# Groundwater Application Review Summary Form

Application # G- 19116

GW Reviewer Darrick E. Boschmann Date Review Completed: 05/10/2021

**A. GENERAL INFORMATION:** Applicant's Name: Allah Bakhsh County: Harney

Well Location Map

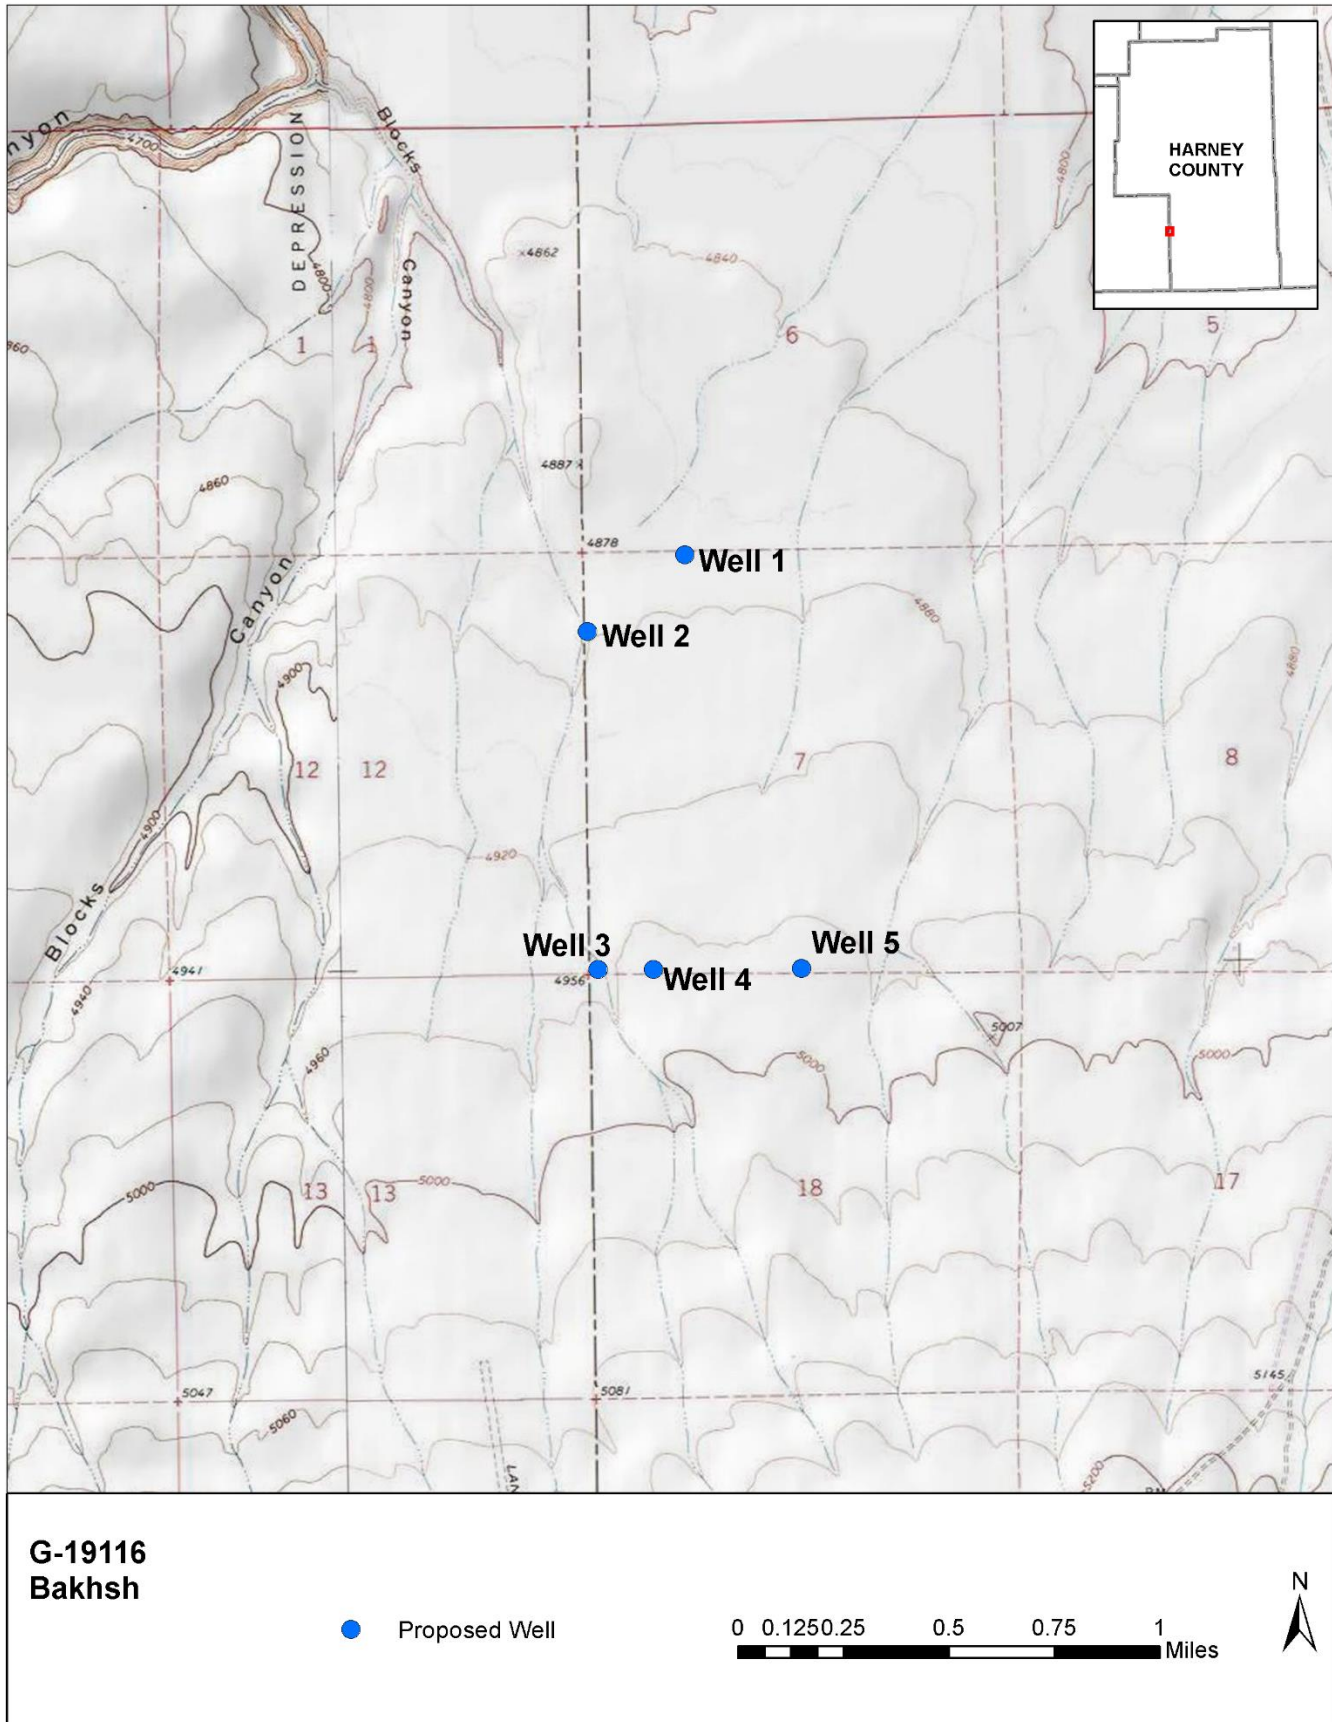
The proposed wells are located in southwest Harney County, along the border with Lake County on the north flank of Beaty Butte. The area underlying the proposed wells is mapped as Tb (Basalt) by Walker and Reppenning, 1965. There are no existing wells in this area.

There are no existing wells or groundwater developments anywhere in this immediate area. Over 5 miles to the west LAKE 51567 was completed to a depth of 760 feet in basalt and reportedly encountered no water. Approximately 8 miles to the east HARN 52610 penetrated 193 feet of clay, ash and pumice overlying basalt and broken rock to a depth of 650 feet and was also reported as a dry hole.

Very little information exists for this location and it is not known if sufficient groundwater will be present at the proposed depth for the proposed use.

The only perennial surface water sources in this area are several springs located upgradient on the flanks of Beatys Butte. Although the groundwater elevation at the location of the proposed wells is unknown, it is below the elevation at which these springs discharge from the butte.
